AC02-S21 Dogbone Correction

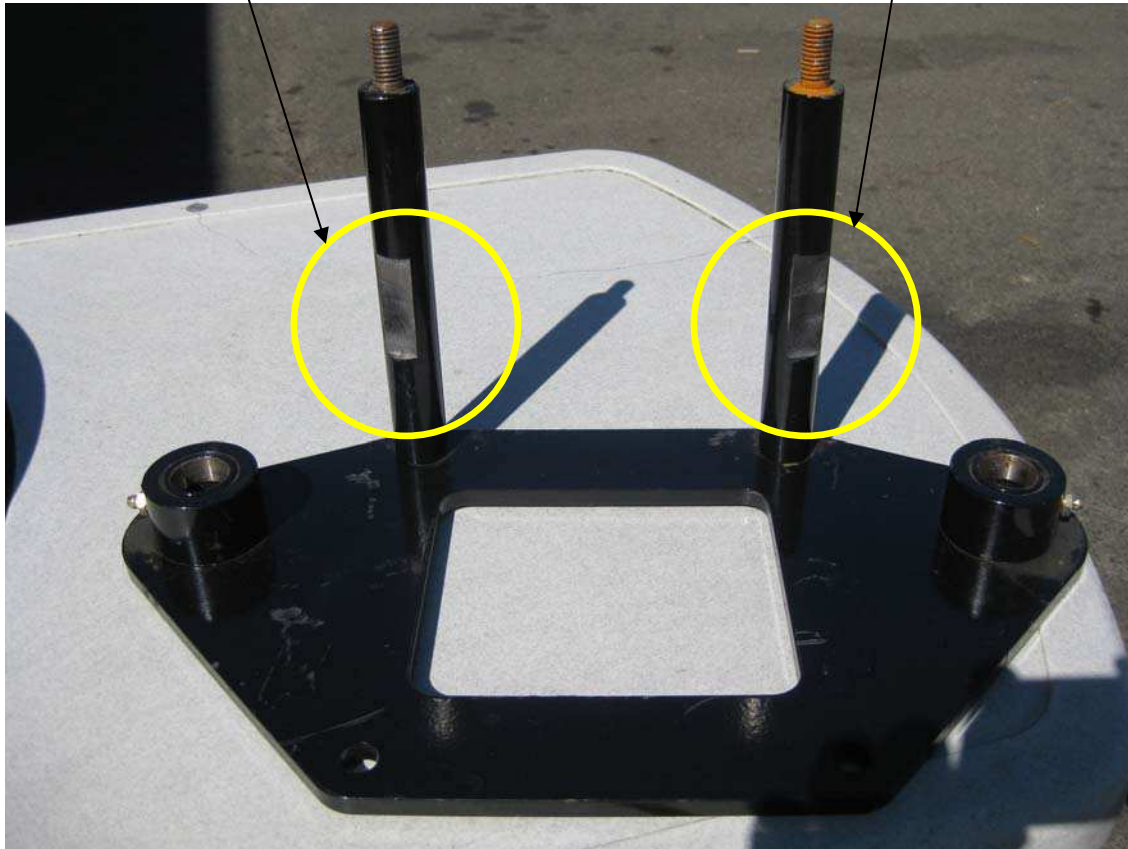
- Issue: It is possible that the link assembly can impact the dogbone spacer causing the linkbar to fail prematurely. In addition, the new linkbar design is thicker requiring this correction to be completed before the new linkbar is installed.
- Correction: Grind spacer Part # AC02-114 1/8" as shown on the photo aside.
- Determine which spacer requires correction – see note on photo.
- To identify the area to grind, inspect the spacer where linkbar is hitting. Mark the area, remove dogbone and grind.
